TO: All Bidders under ITB No. 19-101072, ROAD WIDENING, SIDEWALKS, BIKE LANES (ROCKBRIDGE ROAD - ALLGOOD TO ROWLAND ROAD)

ADDENDUM NO. # 1

PLAN AND PROFILE OF PROPOSED CS 796/ROCKBRIDGE ROAD FROM ALLGOOD ROAD TO ROWLAND ROAD

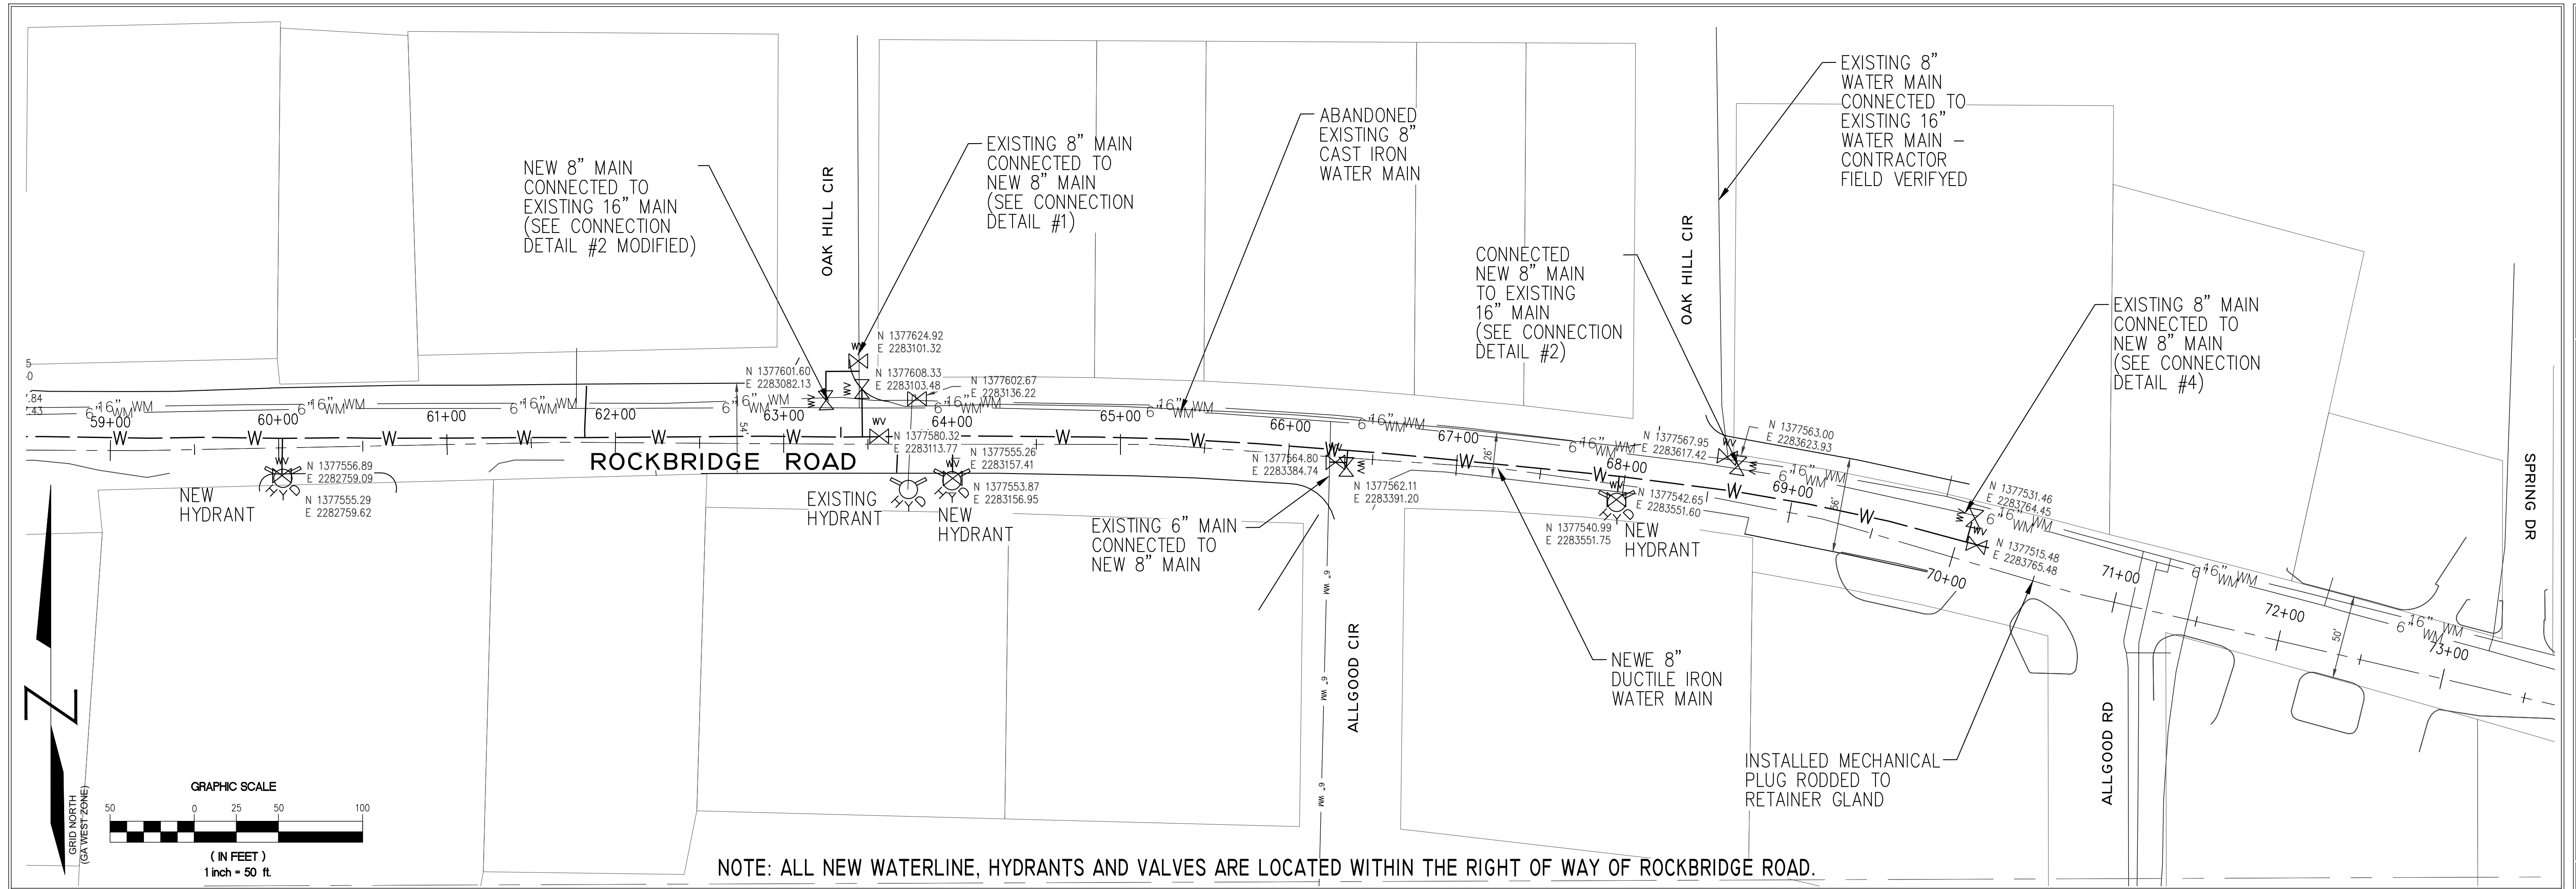
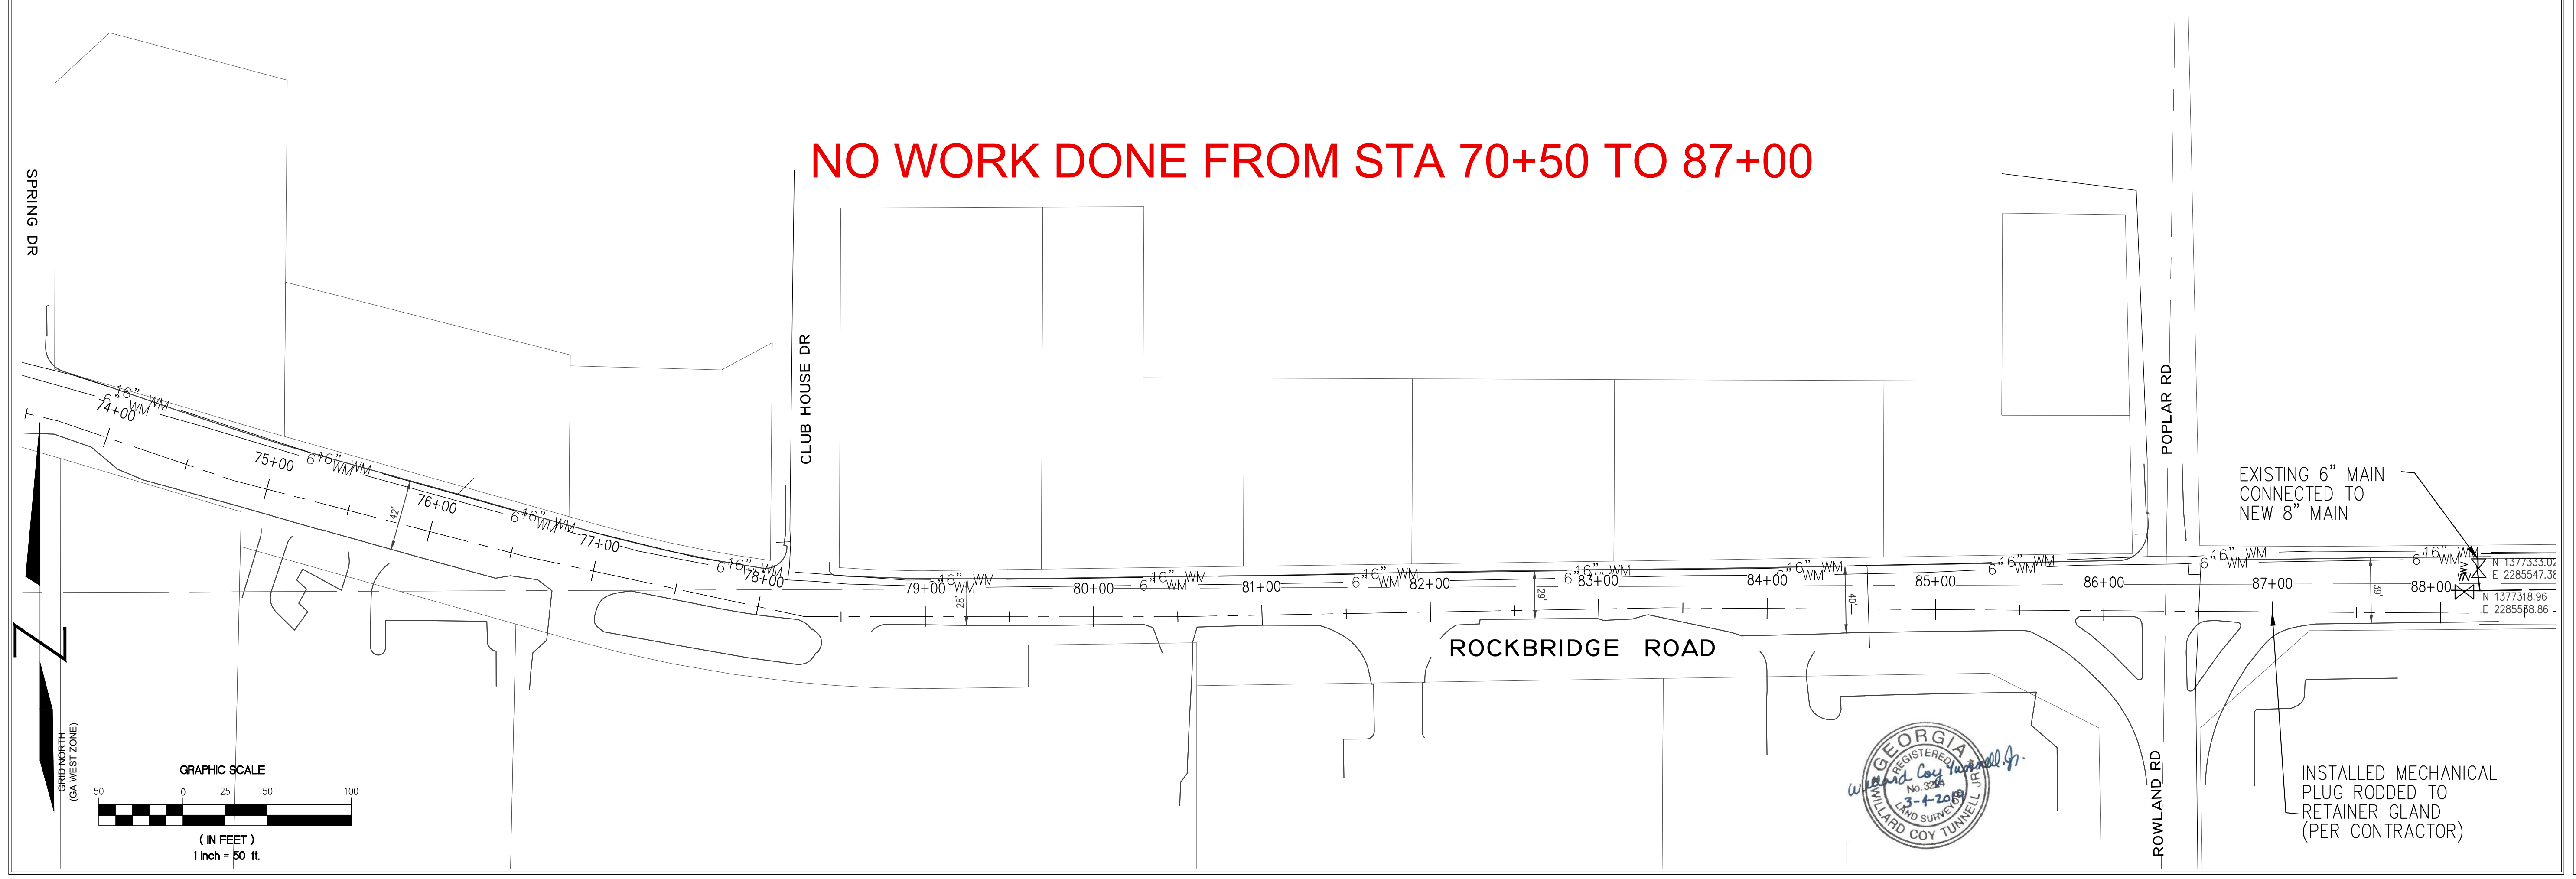
L. Question: According to one of our water subs there was a new water main installed recently from Memorial Drive to N. Deshon. That project skipped over Pine Lake because of this Rockbridge Road project. There are new stub outs on each end of this project that are not reflected on the plans. Should connections to this new water main be incorporated into this project?

Answer: Yes. DeKalb County has recently installed a new 8”waterline on each end of the project. Please refer to the as-builts attached to this addendum. The plugs on the end of the 8” line at each end of the project reflect the approximate location of where the new tie-in is located.

CHECKED:	DATE:	DRAWING No.
		27-0002
BACKCHECKED:	DATE:	
CORRECTED:	DATE:	
VERIFIED:	DATE:

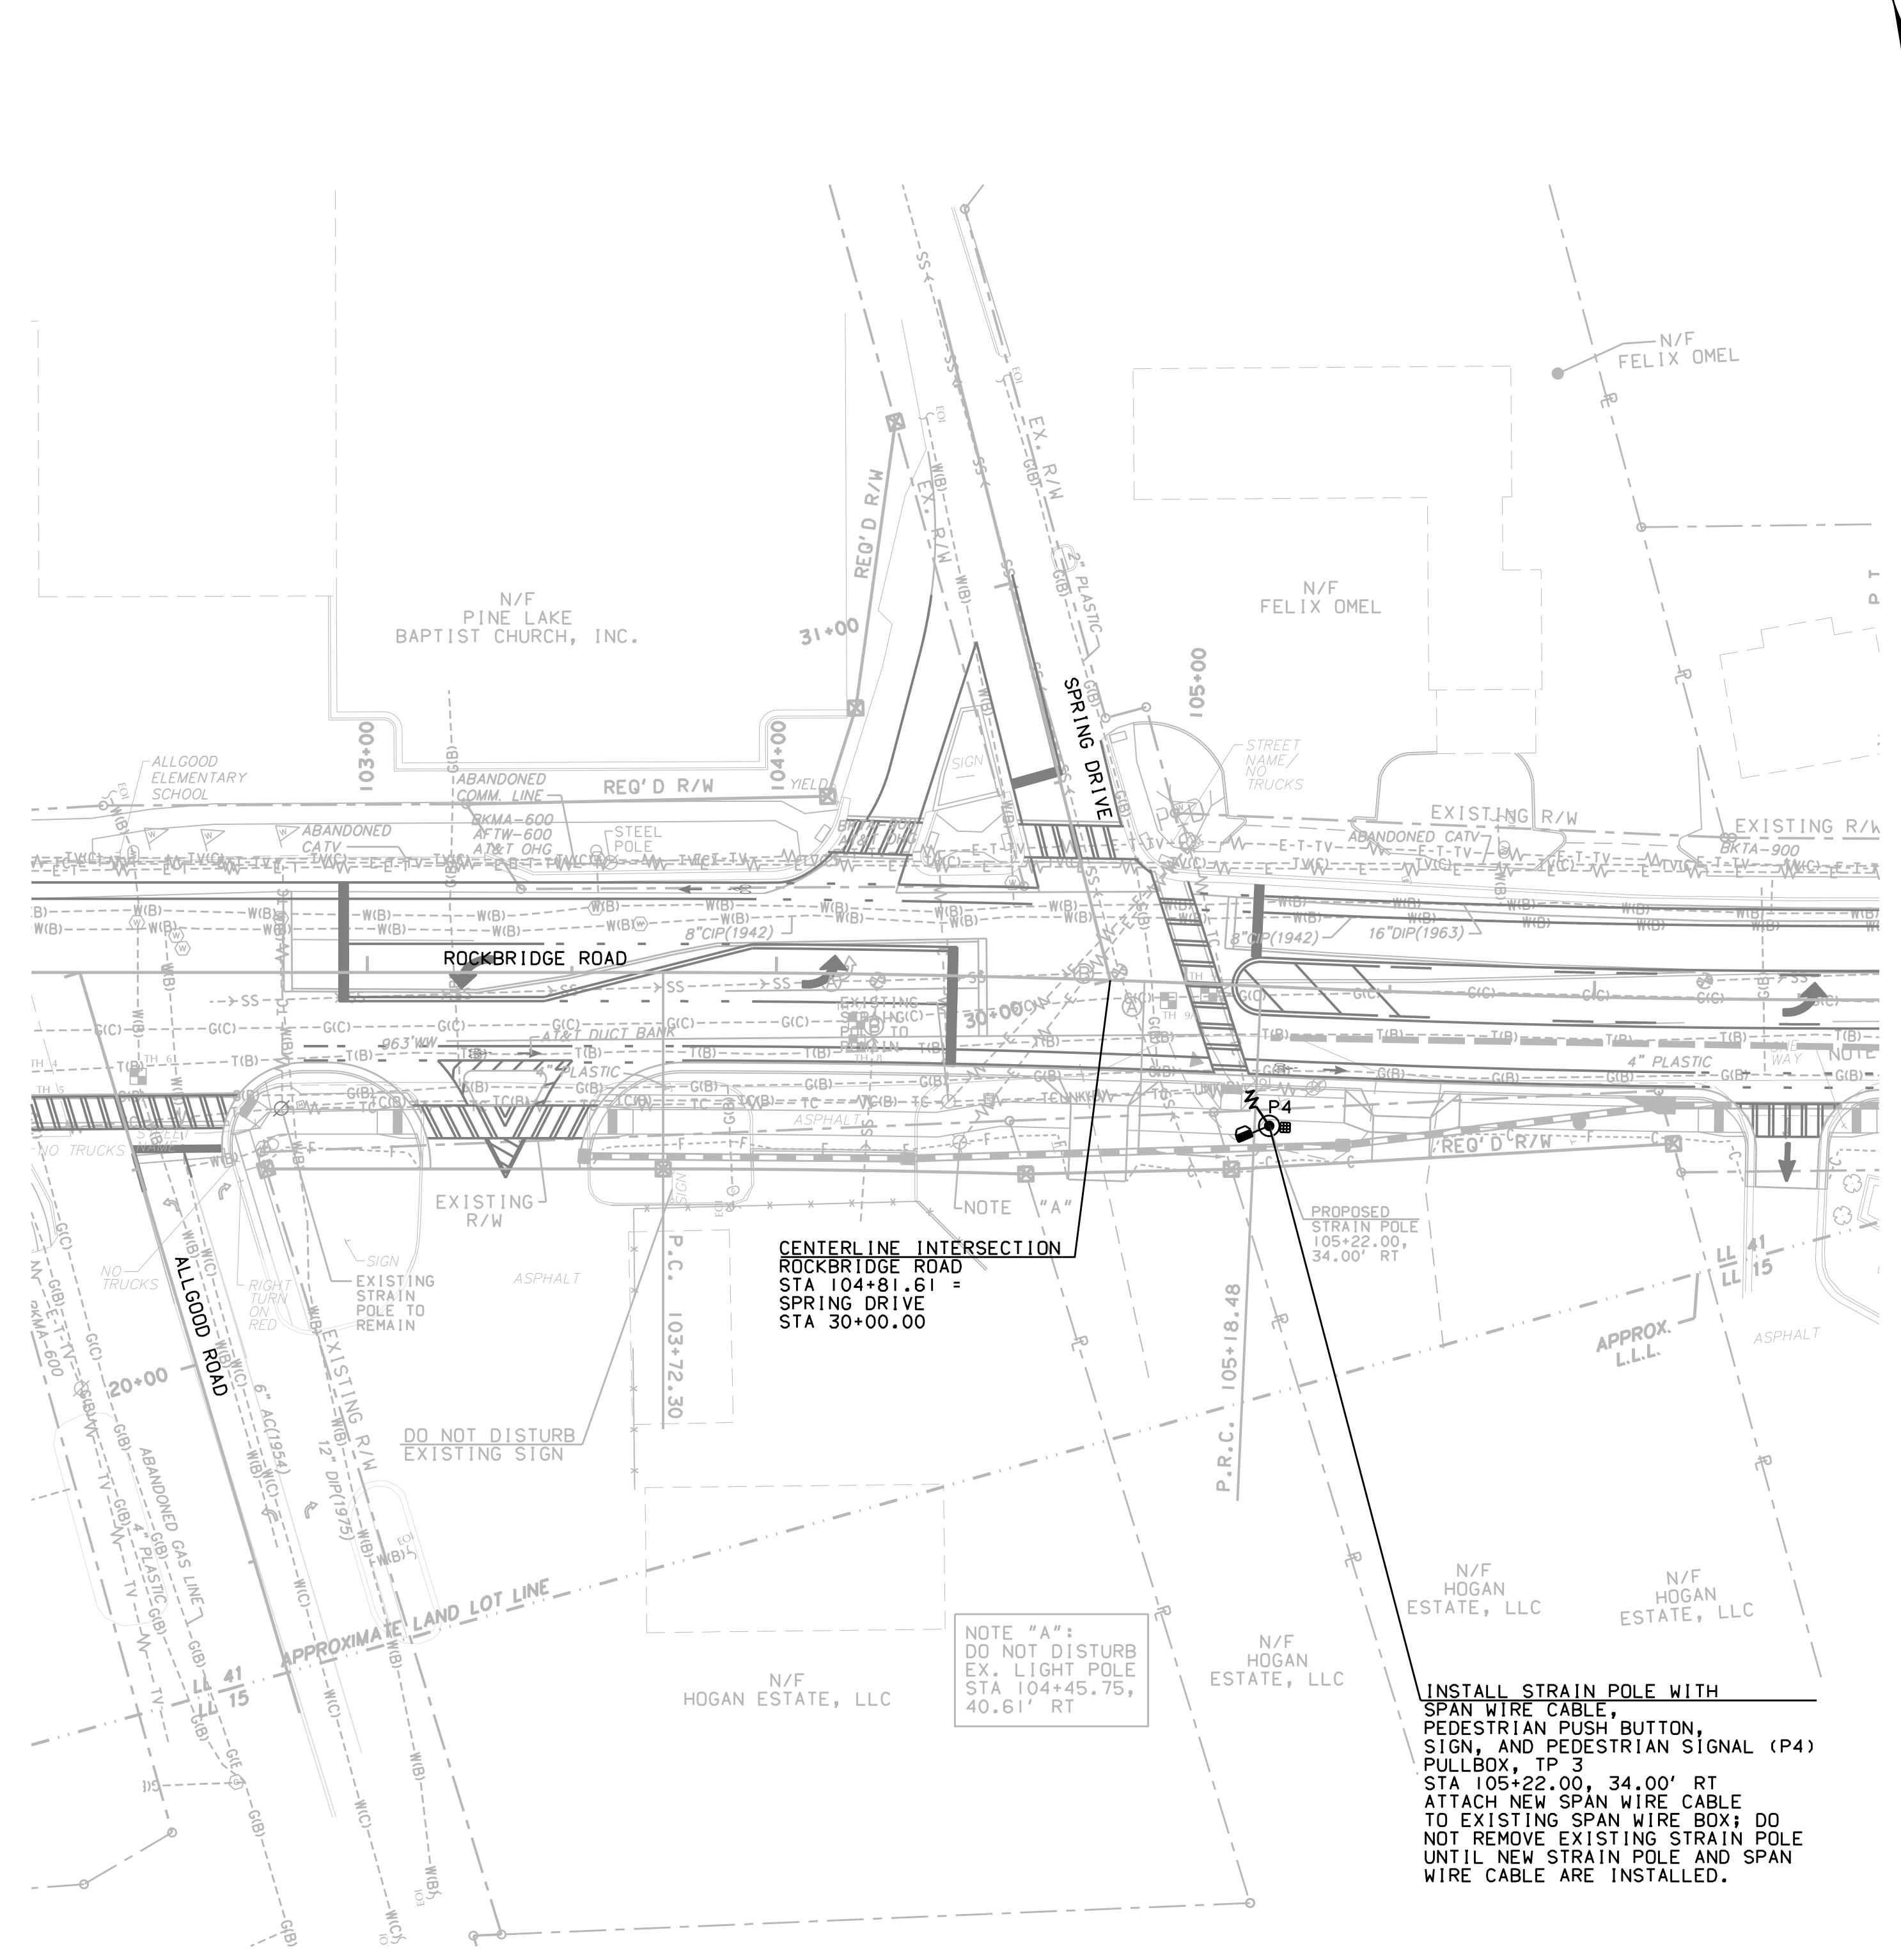
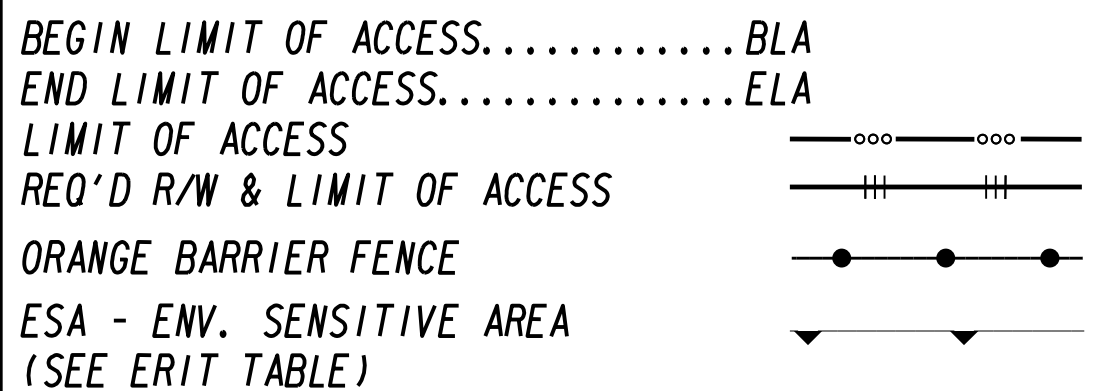
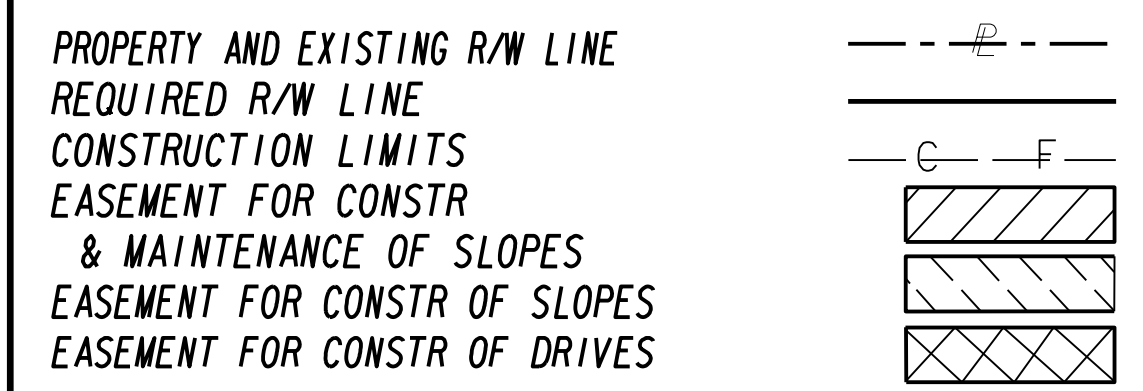
Q. Question: Where does the Type 2 pull box go on this project? It is listed on the LOM on page 27-0002, but I do not see it on the plans.

Answer: Type 2 pull box is not required for this signal. A revised sheet 27-0002 updating the list of materials is attached to this addendum.
